PREPARED FOR THE URBAN DESIGN COMMISSION AND PLAN COMMISSION

**Project Address:** 516-530 Cottage Grove Road  
**Application Type:** Conditional Use  
**Legistar File ID #:** [35558](#)  
**Prepared By:** Heather Stouder, AICP, Planning Division  
Report Includes Comments from other City Agencies, as noted

## Description and Analysis of Revisions and Supplemental Information

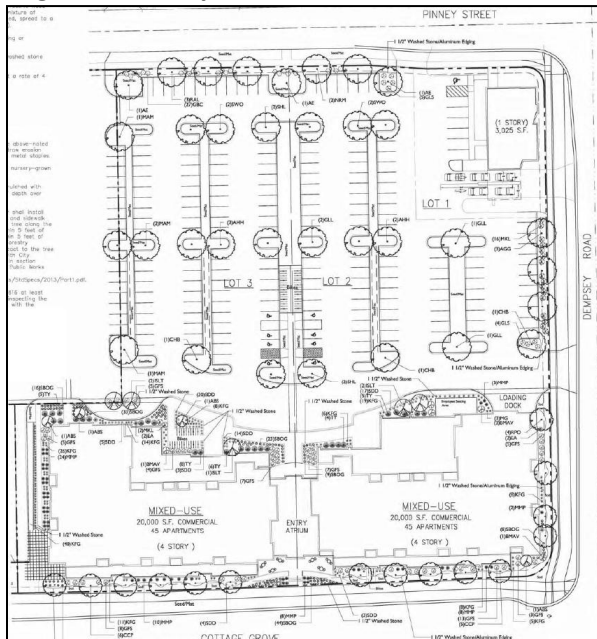
*Parking and Circulation-* The revised proposal has 185 surface parking stalls for automobiles, while the original submittal had 190. This slight reduction is the result of straightening out the drive aisle closest to the building and providing more space on the north side of the building for bicycle parking, landscaping, and gathering.

**February 5, 2015 Landscape Plan**

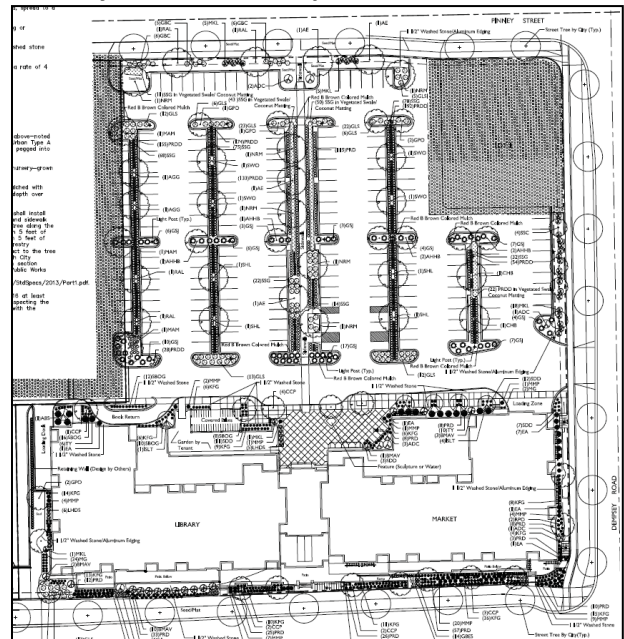
**Landscaping and Other Site Details-** The revised landscape plan provides for a better overall tree distribution in the surface parking area, and a significant increase in lower-level plantings (small trees, shrubs, and perennial grasses) in the landscaped areas between the parking rows. Landscaping near the building is similar, but a new garden area for the library space is provided, and there is a larger pedestrian space near the northern entrance to the building. On the whole, the landscaping points for the site have increased by over 20%.
